Product Change Description

Model Name: T6F10
HW: V1.0(LA+EU)
SW: V3.0.0
FCC ID: 2AH25T6F10

is the variant of the initial certified product,

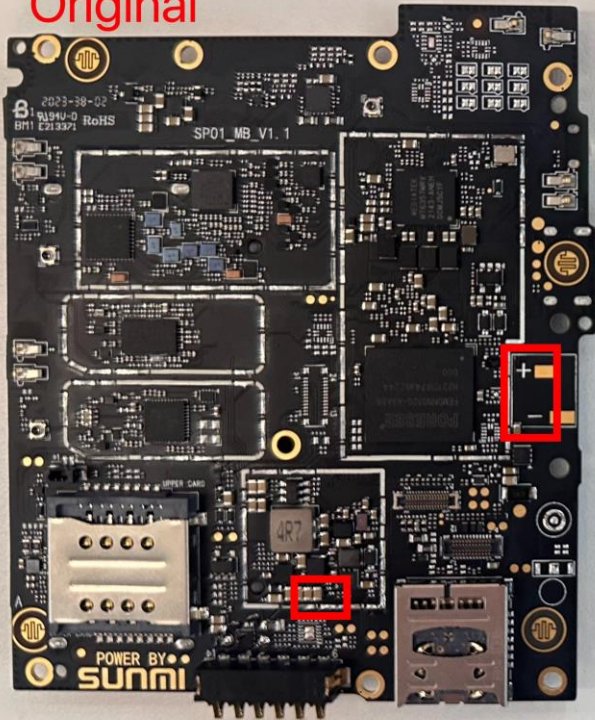
1.The position of the sacnner is changed from vertical to horizontal, and the appearance of the top is changed because of the change of the position of the sacnner.

The difference between the Original and the Variant of PCBA is shown in the following figure:

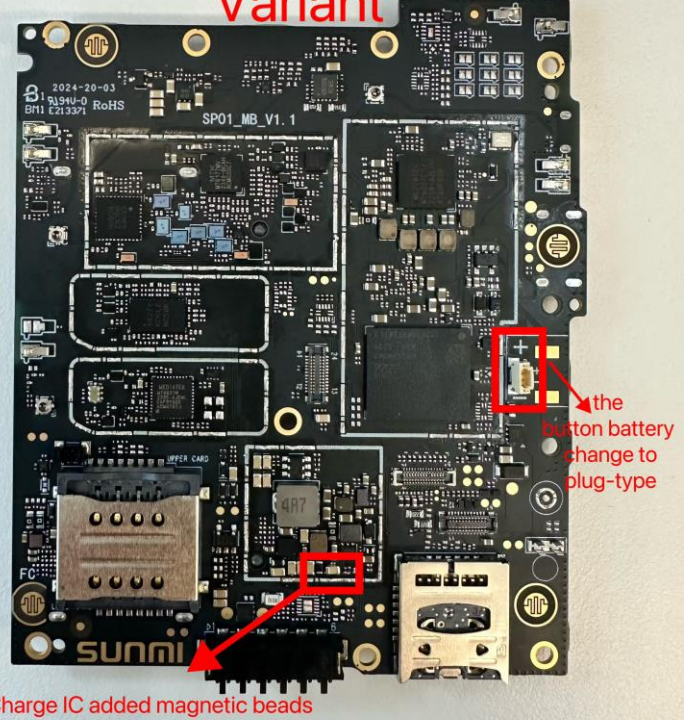
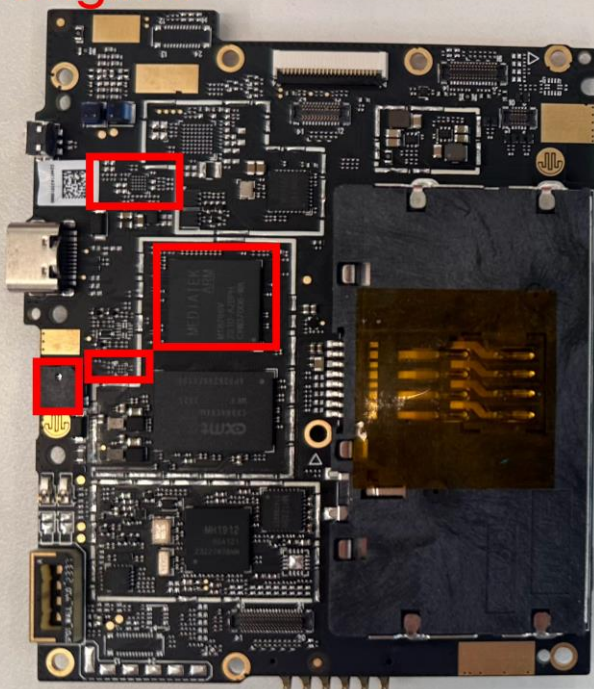
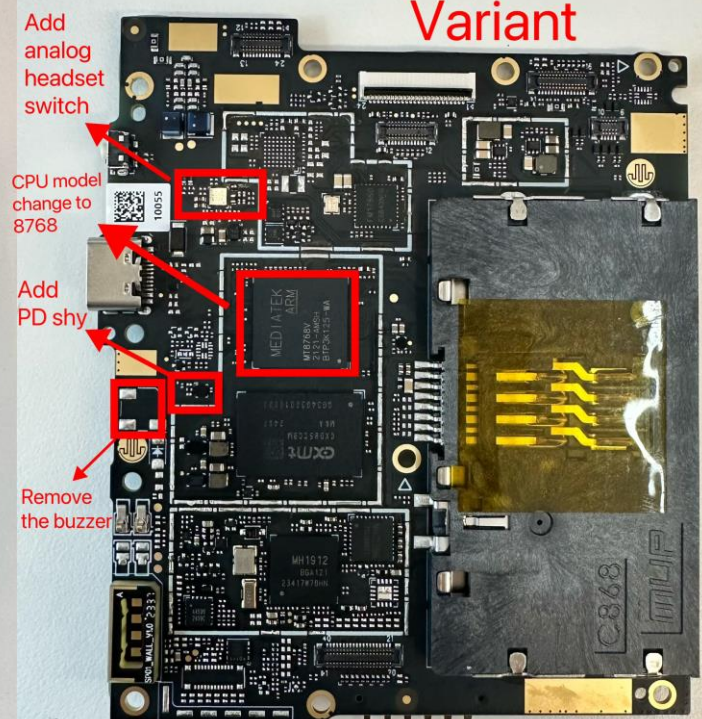
2.PCBA Change

The CPU chip model is changed from 8766 to 8768, and the two CPU chips are PIN to PIN, and the RF performance will not be affected.
